## DEPARTMENT OF PLANNING AND ZONING

Re: DSUP2016-0039  
Amendment to DSP96-0103 & SUP96-103 for a new Elementary School  
1701 & 1705 N. Beauregard Street  
Concept 1&2 Comments

DSUP2016-0039 City Compiled Concept #1 & #2 Comments  
Amendment to DSP96-0103 & SUP96-103 for a new Elementary School  
1701 & 1705 N. Beauregard Street  
October 10, 2016

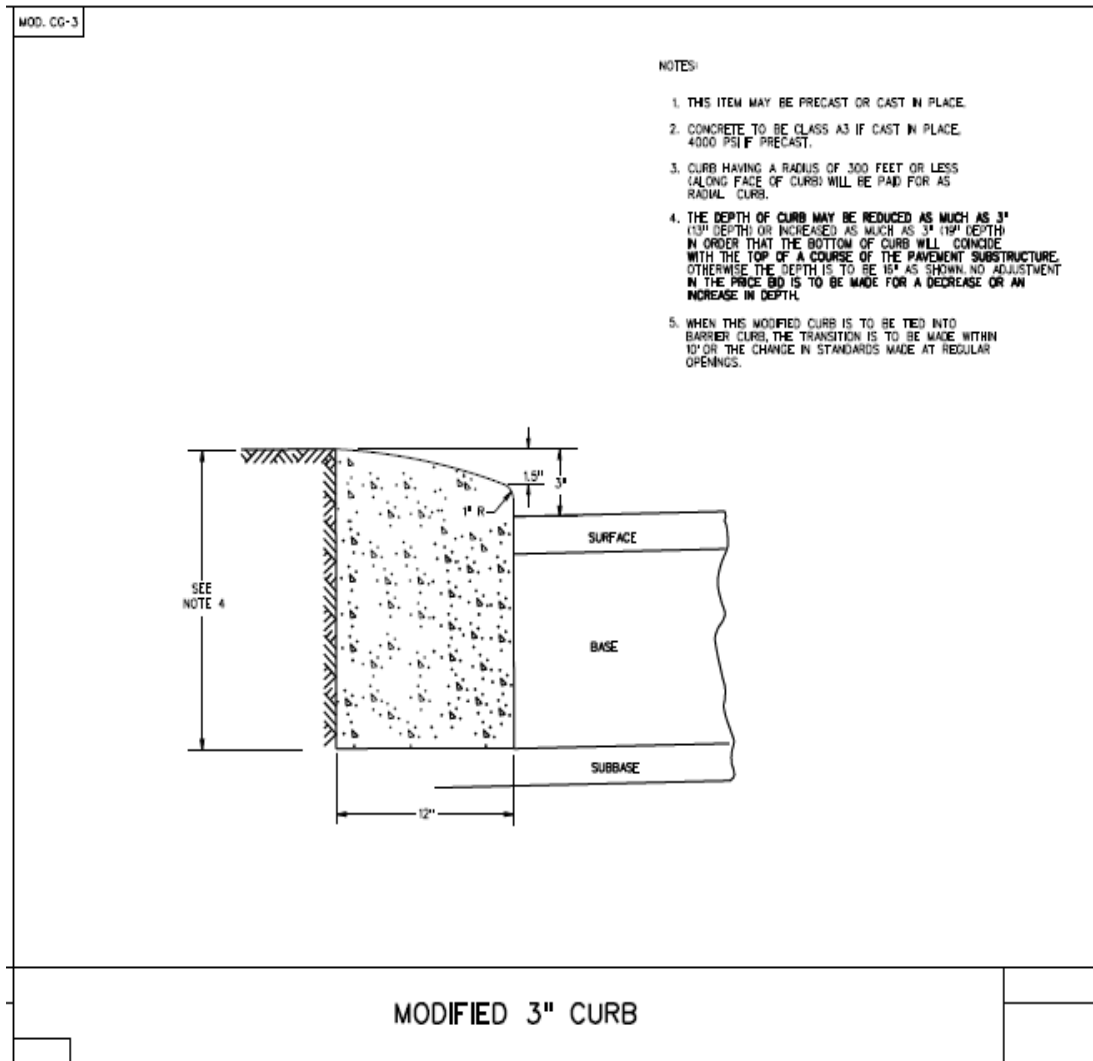
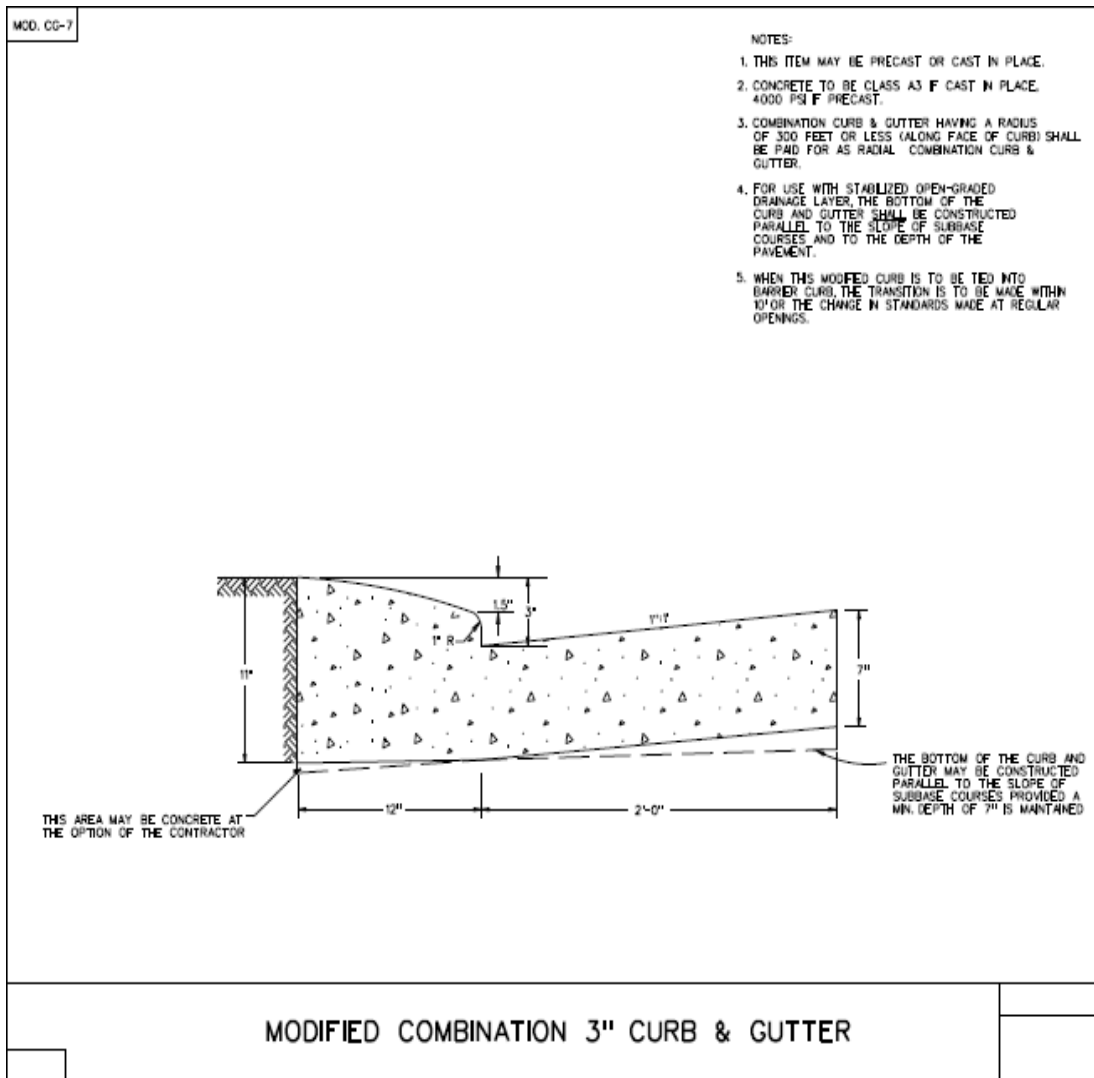
3. The Applicant shall provide a separate Fire Service Plan which illustrates **where applicable**: a) emergency ingress/egress routes to the site; b) location of emergency vehicle easements (EVE) around the building with a minimum width of twenty-two (22) feet.
4. The fire service plan shall show placement of emergency vehicle easement signs. See sign detail and placement requirements are as follows:

Emergency vehicle easements shall be a minimum of 22 feet across the travel lane. The emergency vehicle easement shall provide access to strategic areas of the building and fire protection systems. Curbing and street components shall conform to the standards established by Transportation and Environmental Services and this document for emergency vehicle easements.

Emergency vehicle easement signs shall be metal construction, 12-inches wide and 18 inches in height. Provide red letters on reflective white background with a 3/8-inch red trim strip around the entire outer edge of the sign. The lettering shall say "NO PARKING," "FIRE LANE," "EM. VEH. EAS.," and "City of Alex.," Lettering size shall be as follows: "NO PARKING" - 2 inches, "FIRE LANE" - 2½ inches. EM. VEH. EAS. - 1 inch, CITY OF ALEX. - ½ inch. Directional Arrows - 1 inch by 6 inches solid shaft with solid head - 1½ inches wide and 2 inches deep (For examples, see Figures D102.1, D102.2, and D102.3). Signs shall be mounted with the bottom of the sign 7 feet above the roadway, and shall be properly attached to a signpost or other approved structure such as designated by the fire official. Posts for signs, when required, shall be metal and securely mounted. Signs shall be parallel to the direction of

vehicle travel and posted so the directional arrows clearly show the boundaries and limits of the Emergency Vehicle Easement. In areas where emergency vehicle easements involve two-way traffic, double mounted signs shall be provided. The maximum distance between signs shall be 100 feet. Other special signs or modifications to emergency vehicle easement signs shall be approved by the fire official.

Where curbing is a component of the emergency vehicle easement, the curbing construction shall conform to weight and grade requirements for vehicular traffic. In no circumstances shall a raised curb be located in the path of travel in an emergency vehicle easement. Where a mountable curb is provided as part of an emergency vehicle easement, emergency vehicle easement signs shall be posted at the point nearest the edge of the emergency vehicle easement, but in no case within the clear width of the emergency vehicle easement. With the exception of flush curbs, any fire department access points that require fire apparatus to mount a curb shall conform to the modified 3 inch curb design standard MOD CG-3 or MOD CG-7 design as shown.
